From: [Anna Pittala](#)
To: [Rivera, Andrew](#)
Subject: Fwd: Request for Omitted Information ASMP Street Network Amendments Spreadsheet by District
Date: Tuesday, April 5, 2022 1:57:04 PM
Attachments: [image006.png](#)
[image010.png](#)
[image009.png](#)
[image005.png](#)
[image008.png](#)
[image003.png](#)
[image004.png](#)
[image007.png](#)
[image001.png](#)

From: Austin Strategic Mobility Plan <ASMP@austintexas.gov>
Date: Wed, Mar 30, 2022 at 2:16 PM
Subject: RE: Request for Omitted Information ASMP Street Network Amendments Spreadsheet by District
To: Anna Pittala <annapittala@gmail.com>, Austin Strategic Mobility Plan <ASMP@austintexas.gov>
CC: SouthwoodOfficers@gmail.com <SouthwoodOfficers@gmail.com>

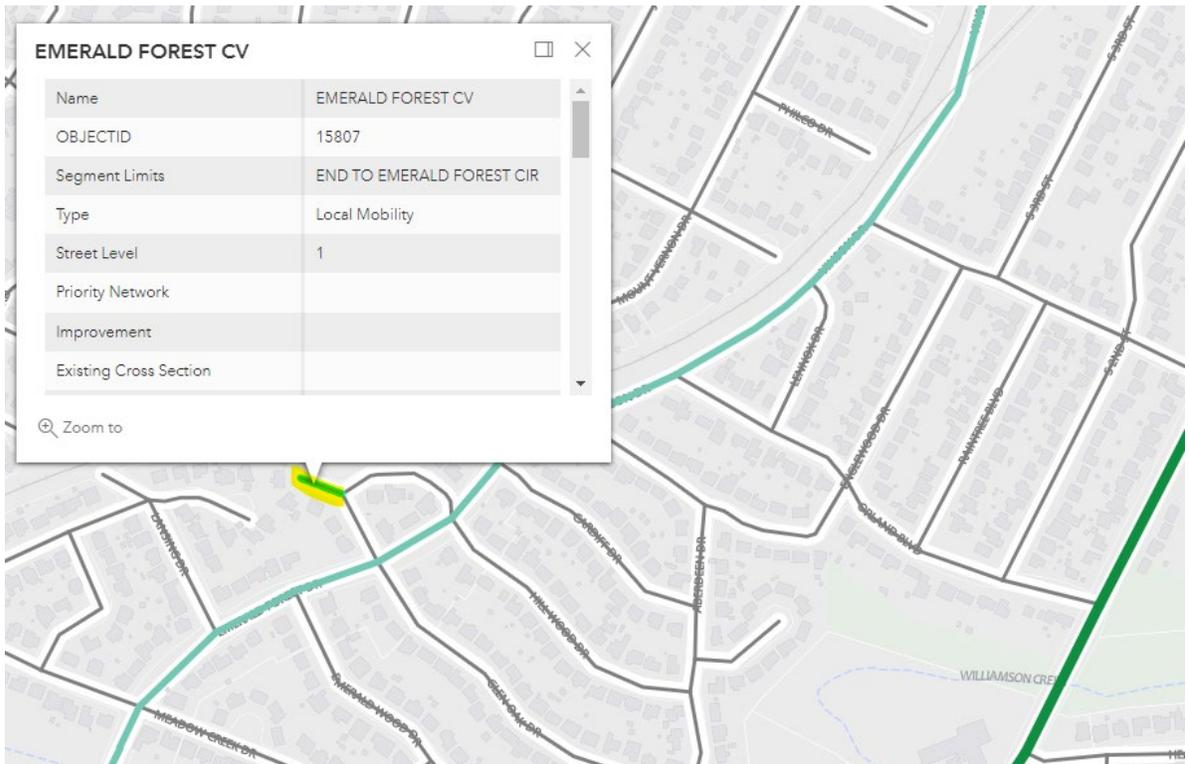
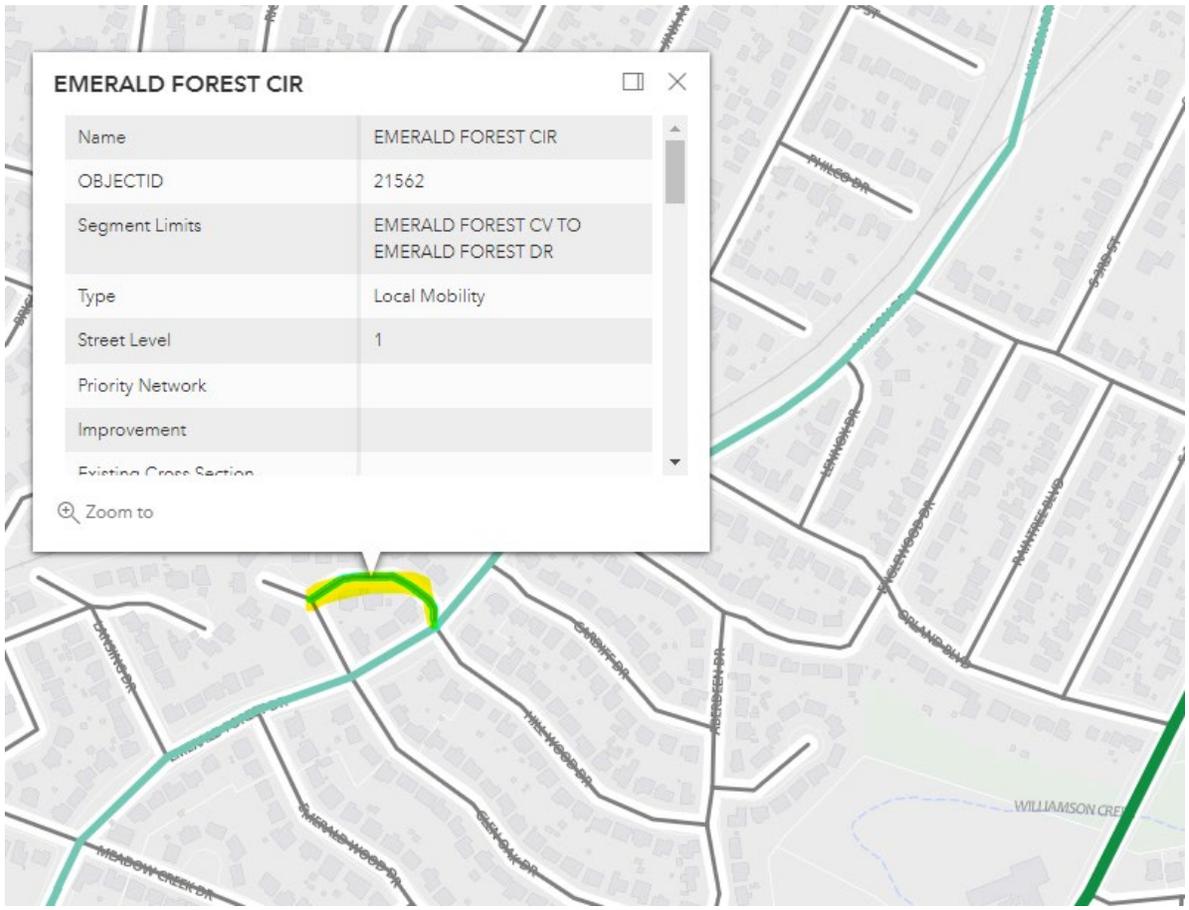
8. I have a question about Vinson and the drawing of the property lines you drew in red and the yellow Railroad line. The red property line West of the Railroad doesn't seem

applicable to this conversation because the main Railroad line will not be moving and those house are in the opposite side of the Railroad line. Can you provide the numbers on the combined Vinson and Railroad ROW, so the homeowners know where the current ROW lands on their properties? If the improvements will be made within the existing ROW, the homeowners should have the right to know where that line is on their properties?

I have a question about Vinson and the drawing of the property lines you drew in red and the yellow Railroad line. The red property line West of the Railroad doesn't seem applicable to this conversation because the main Railroad line will not be moving and those house are in the opposite side of the Railroad line. Can you provide the numbers on the combined Vinson and Railroad ROW, so the homeowners know where the current ROW lands on their properties? If the improvements will be made within the existing ROW, the homeowners should have the right to know where that line is on their properties?

- a. As mentioned above, the most accurate source of information for a homeowner to find the existing ROW is the property survey that was conducted when they purchased the home. They can also consult the [Property Profile](#) tool to see the Appraisal District's GIS data for a rough estimate. The answer to this [FAQ](#) may also help people understand that their property line ends and the right of way begins in what many consider their yard, but it's actually public property. Based on the old standards this is often 10 feet behind the face of the curb, but homeowners should always consult their property survey to know for sure.

The adopted Level 2 Street referenced in your email below also did not have an existing ROW calculated based on the unique configuration of the right of way. Vinson Dr shares right of way with the adjacent railroad right of way, so the GIS calculation for existing ROW was not included in the adopted Street Network. [railroad highlighted and existing property lines shown in red]

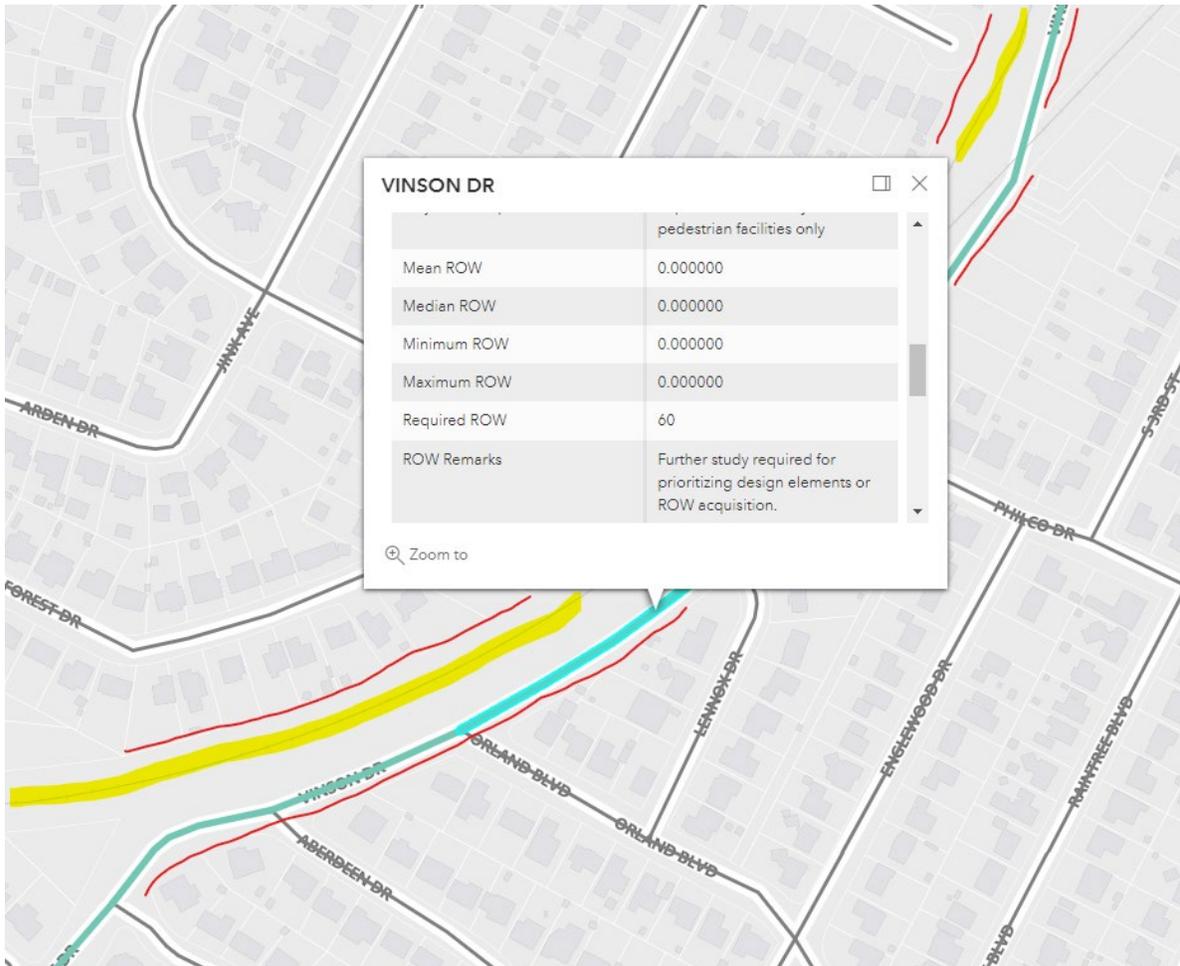
Additionally, the roadways referenced as missing in your email are shown below [highlights added]

The currently adopted Level 1 Streets were always blank, per the paragraph found in the adopted [Street Network Table here](#), "Level 1 streets (local streets) with improvements identified are included in the Street Network Table. Level 1 streets without improvements identified **were not evaluated** for right of way constraints and are all required to be 50 feet in constrained conditions and 60 feet in greenfield developments." [emphasis added]
